# UNITED STATES PATENT AND TRADEMARK OFFICE

APPLICATION NO.	FILING DATE	FIRST NAMED INVENTOR	ATTORNEY DOCKET NO.	CONFIRMATION NO.
10/615,146	07/08/2003	Thomas Kuckelkorn	2678	8229

## Office Action Summary

## DETAILED ACTION

Figure 4 of US004231353 (KANATANI et al) shows:

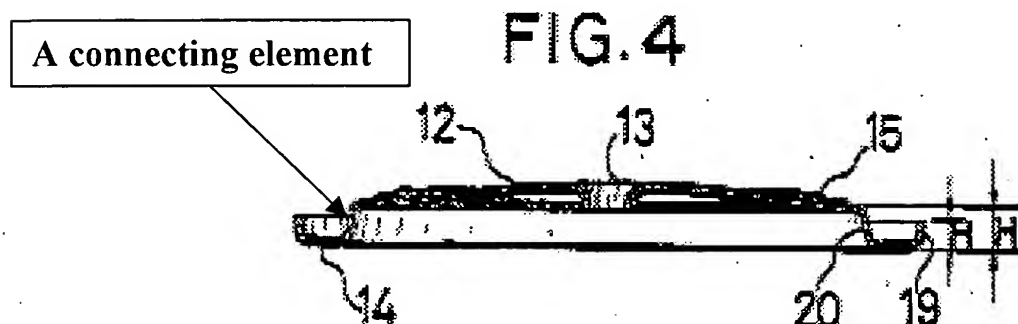
In regard to claims **44 and 45**, **US004231353 (KANATANI et al)** shows (Figure 4) and discloses:

- the interior end (not referenced) of the folding bellows (15) is connected with the glass sleeve tube (9) by a connecting element (20; see annotated figure 4 herein below) and by the glass-metal transitional element (19).

FIG. 4

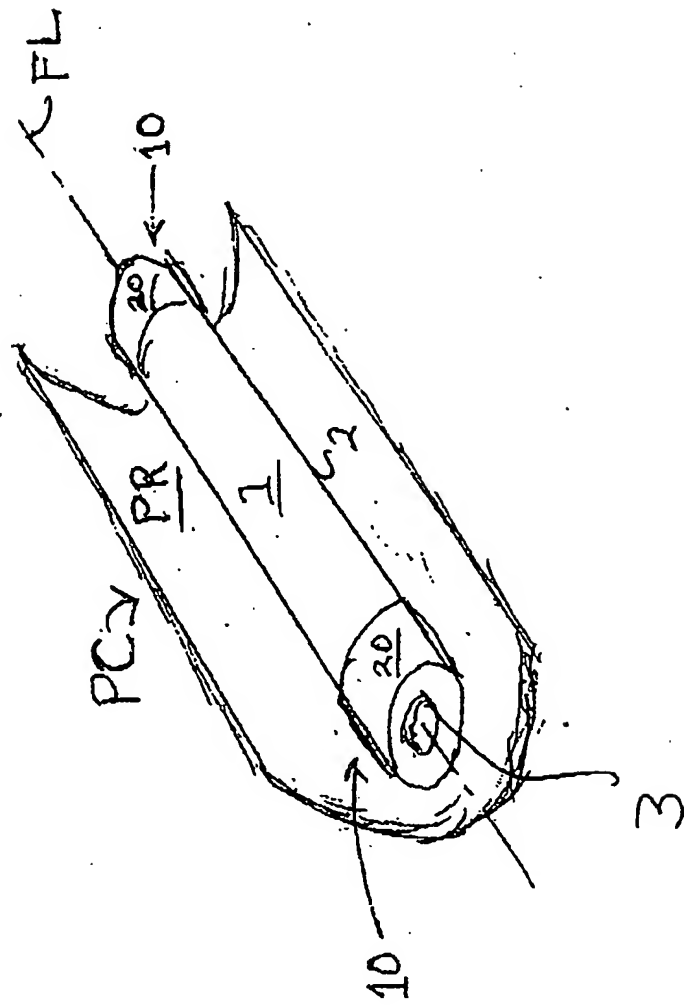
The drawings filed on 06-20-2005 (New Figure 4) are not correctly labeled as “New Sheet” pursuant to 37 CFR 1.121(d). Accordingly, replacement drawing sheets in compliance with 37 CFR 1.121(d) are required in reply to this Office action. If the changes are not accepted by the examiner, the applicant will be notified and informed of any required corrective action in the next Office action.

NOT APPROVED  
7/5/05  
MUST BE  
MAKED "NEW"  
SHEET  
NOT RE-LEGEND  
SHEET
